RHODE ISLAND DEPARTMENT OF TRANSPORTATION

Bridge Group 54A -Kingston Rd Bridge

NOTICE TO PROSPECTIVE BIDDERS

ADDENDUM NO. 2 Prospective bidders and all concerned are hereby notified of the following changes in the Plans, Specifications, Proposal and Distribution of Quantities for this contract. These changes shall be incorporated in the Plans, Specifications, Proposal and Distribution of Quantities, and shall become an integral part of the Contract Documents.

FRAMING PLAN

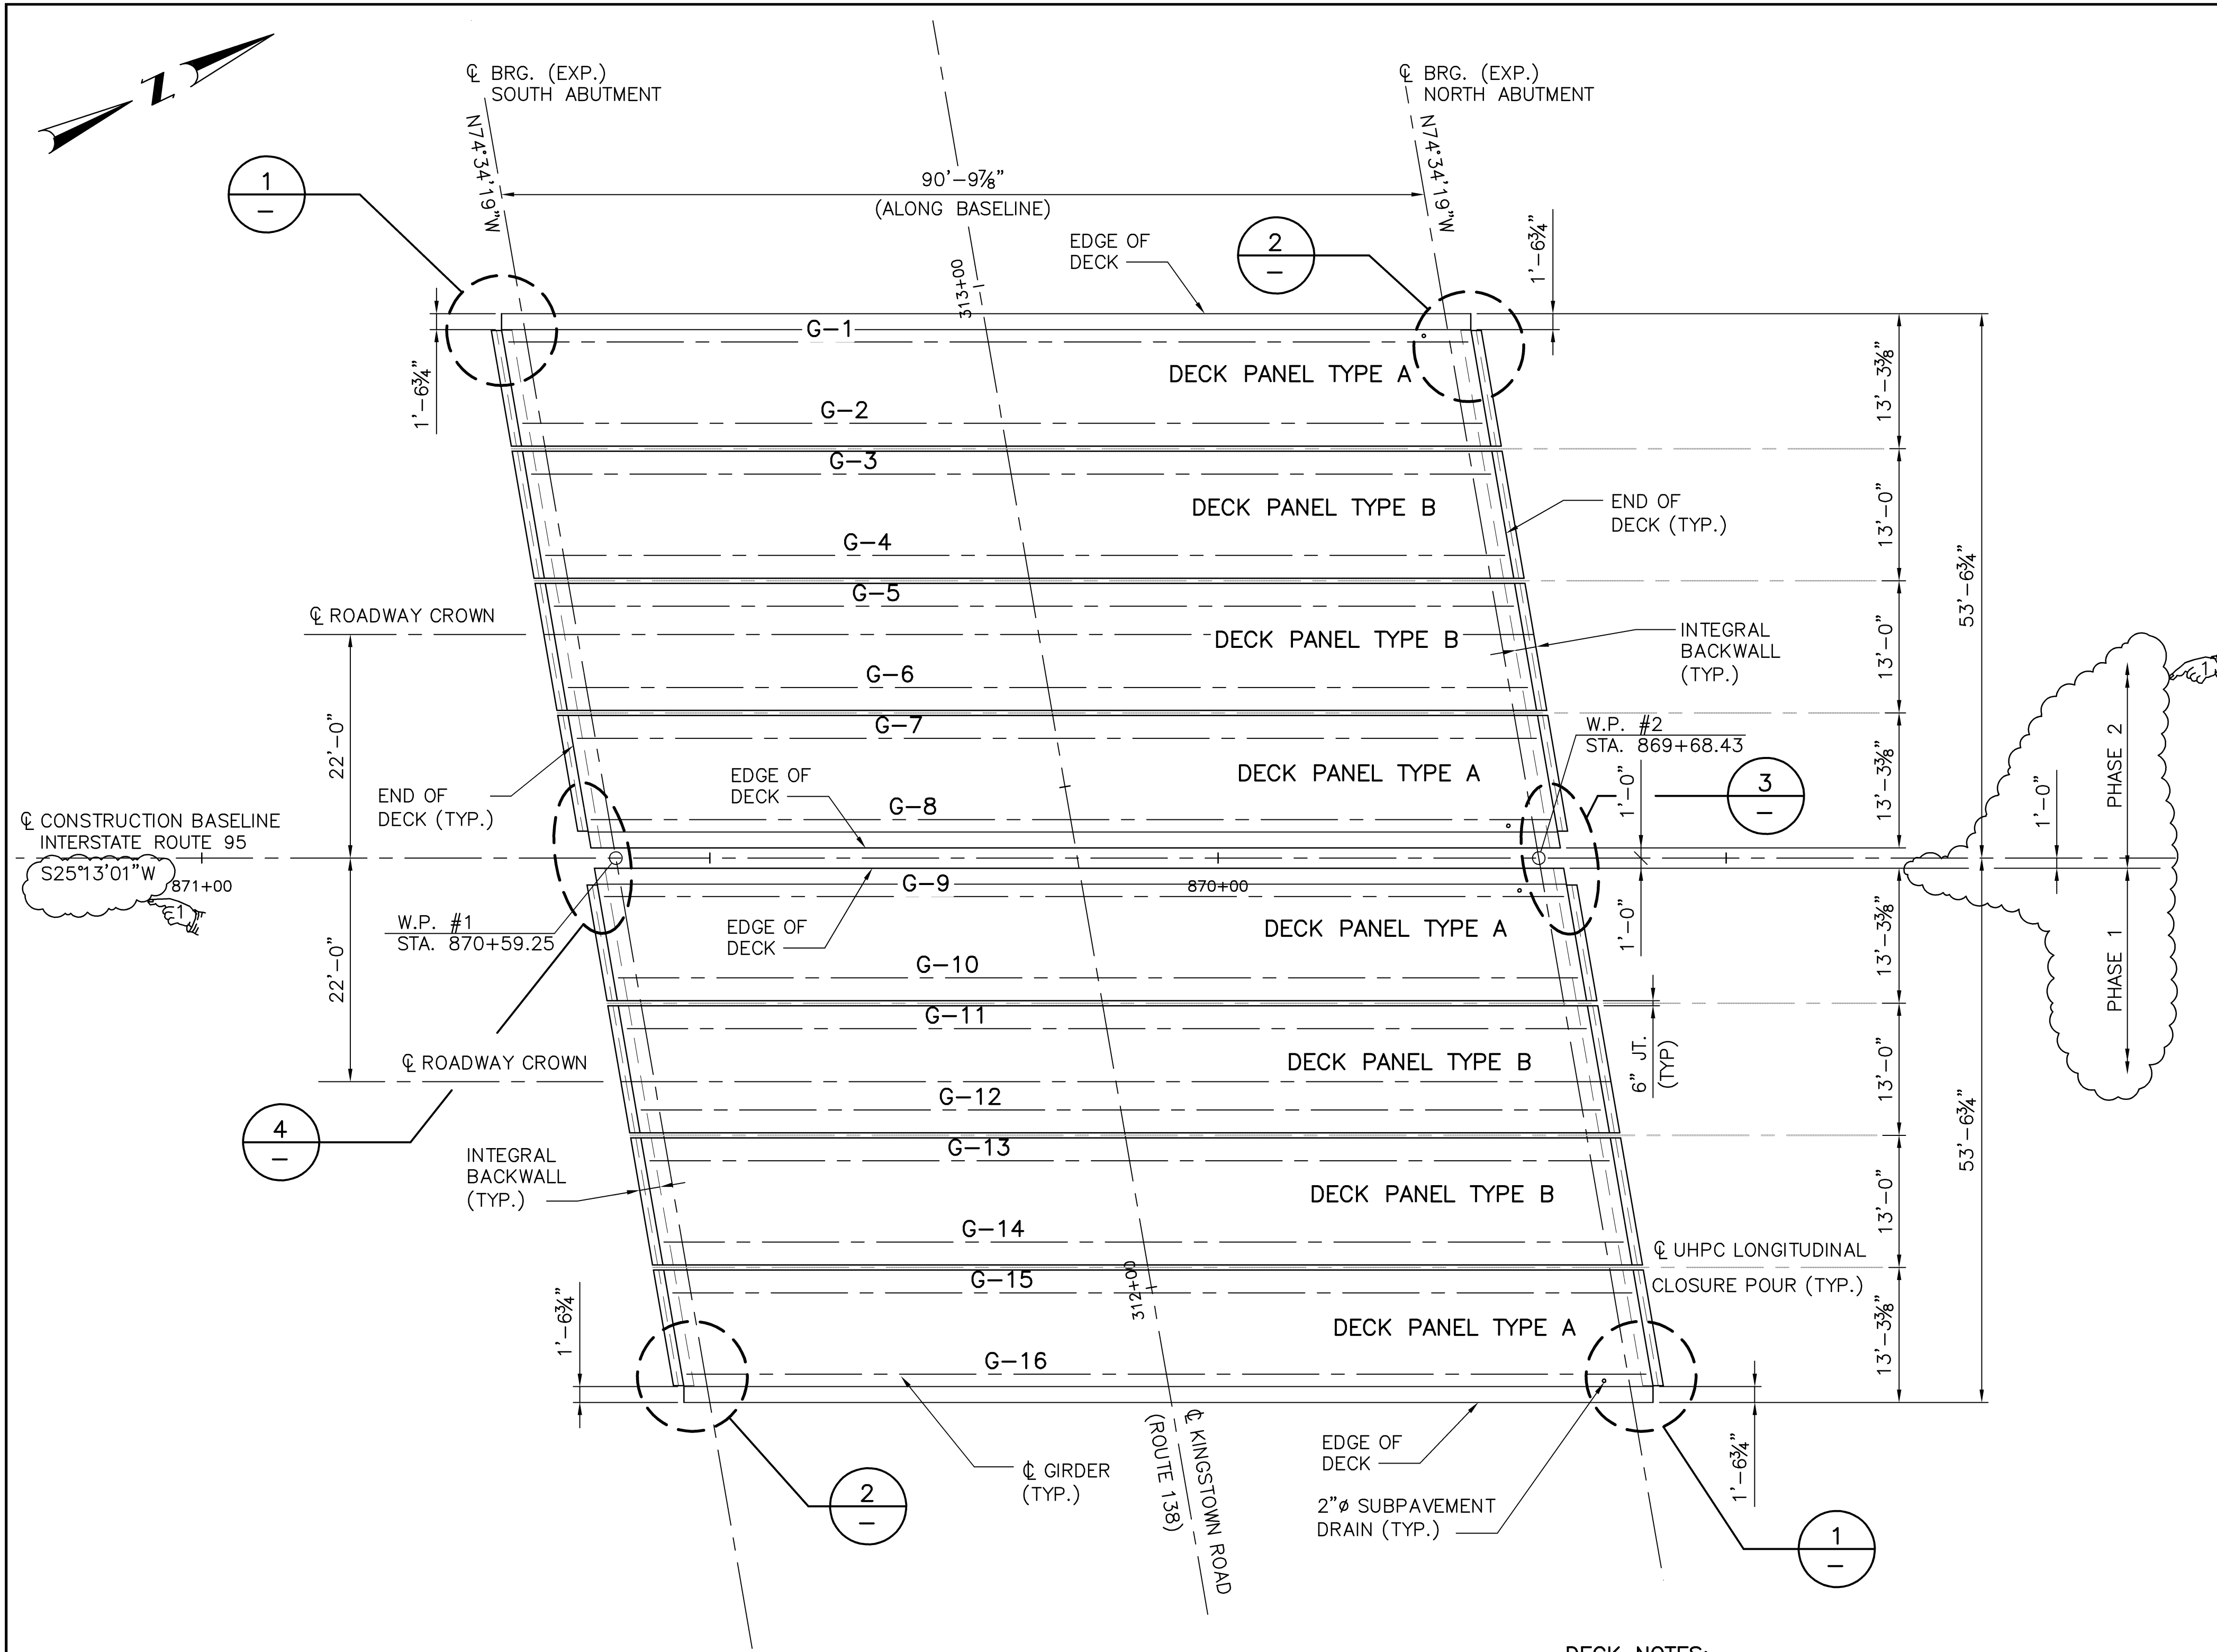
7. Volume 2 Plan Sheet No. 26 - Framing Plan
Remove Volume 2 Sheet No. 26 in its entirety and replace it with revised Sheet No. 26 (R-1) attached to this Addendum No. 2. Framing Plan sheet has been revised.

BRIDGE REPLACEMENT
BRIDGE GROUP 54A -
I-95 KINGSTON ROAD
 RICHMOND, RHODE ISLAND
 KINGSTON ROAD BRIDGE No. 403
PRE-FABRICATED BRIDGE UNITS
DETAILS SHEET 1

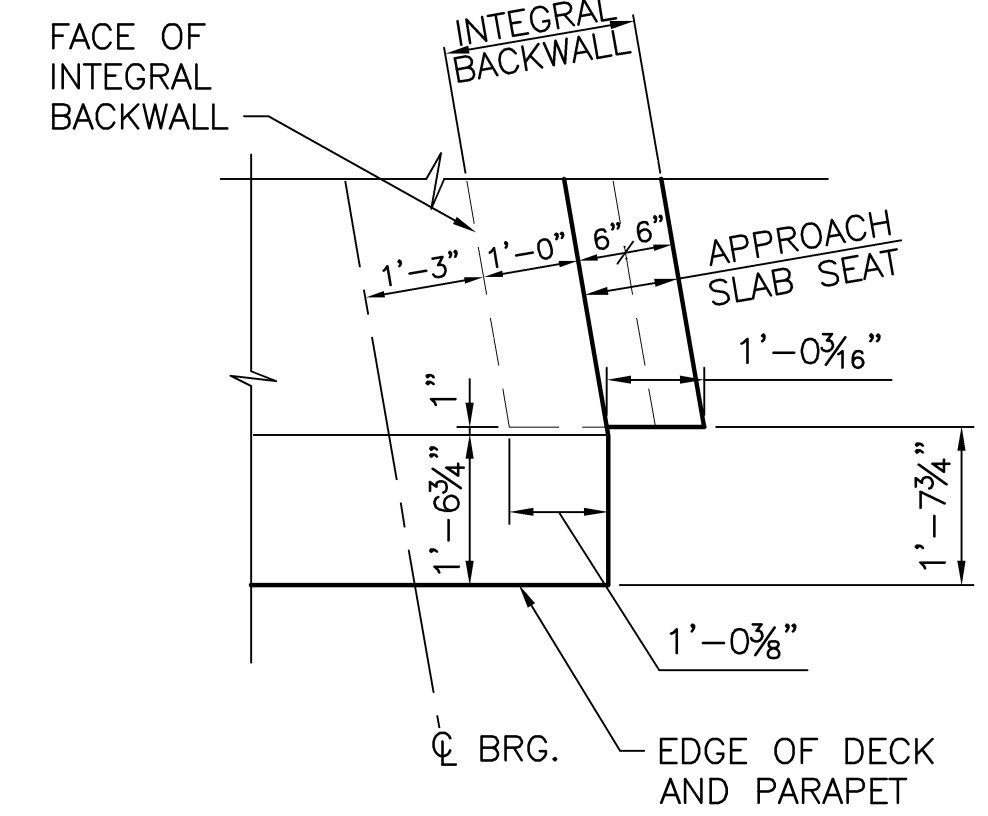
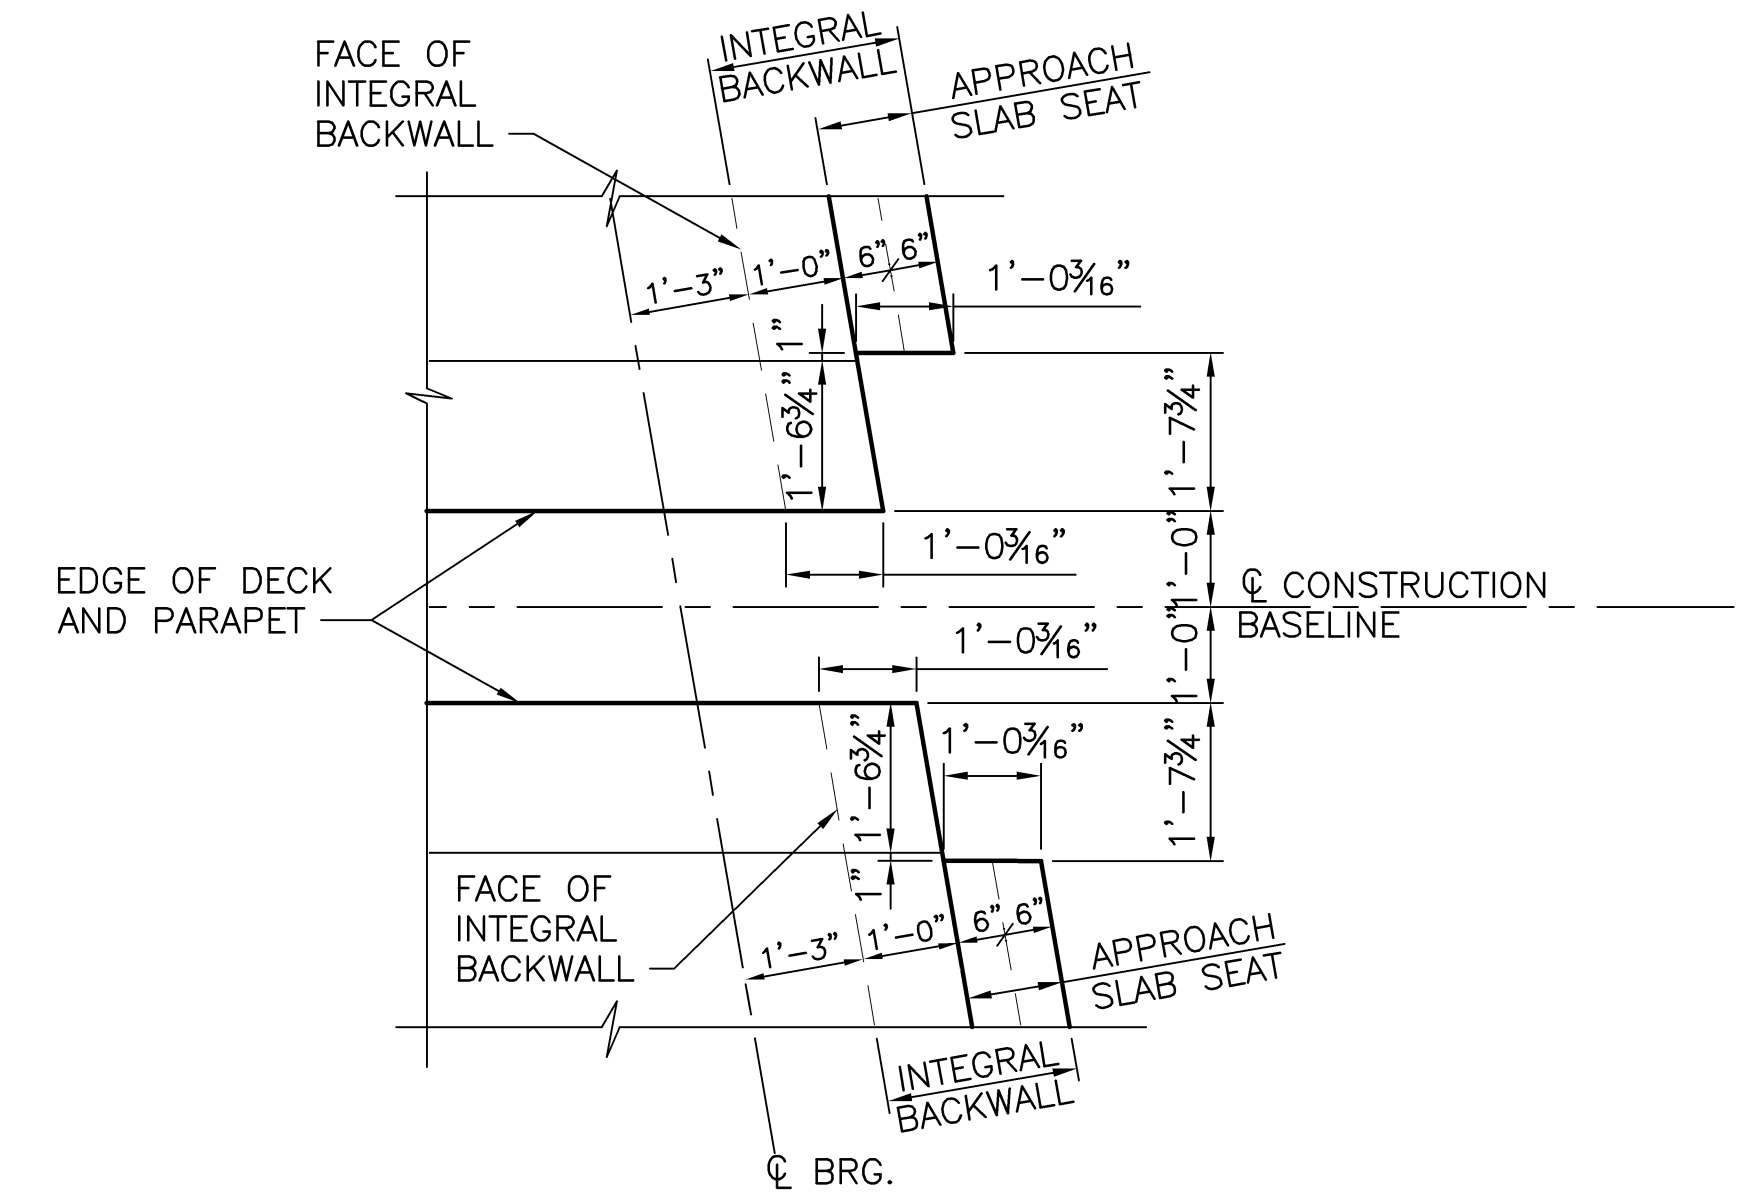
8. Volume 2 Plan Sheet No. 32 - Pre-Fabricated Bridge Units Details Sheet 1
Remove Volume 2 Sheet No. 32 in its entirety and replace it with revised Sheet No. 32 (R-1) attached to this Addendum No. 2. Pre-Fabricated Bridge Units Details Sheet No. 1 has been revised.

Will stay-in-place forms be allowed to fabricate the PBU's?

RIDOT will allow use of stay-in-place forms (SIP's). The SIP's shall be designed and detailed to produce the dimensional requirements indicated on the Contract Drawings. All associated design, details, and product specifications shall be provided by the Contractor for review and approval by the Engineer.
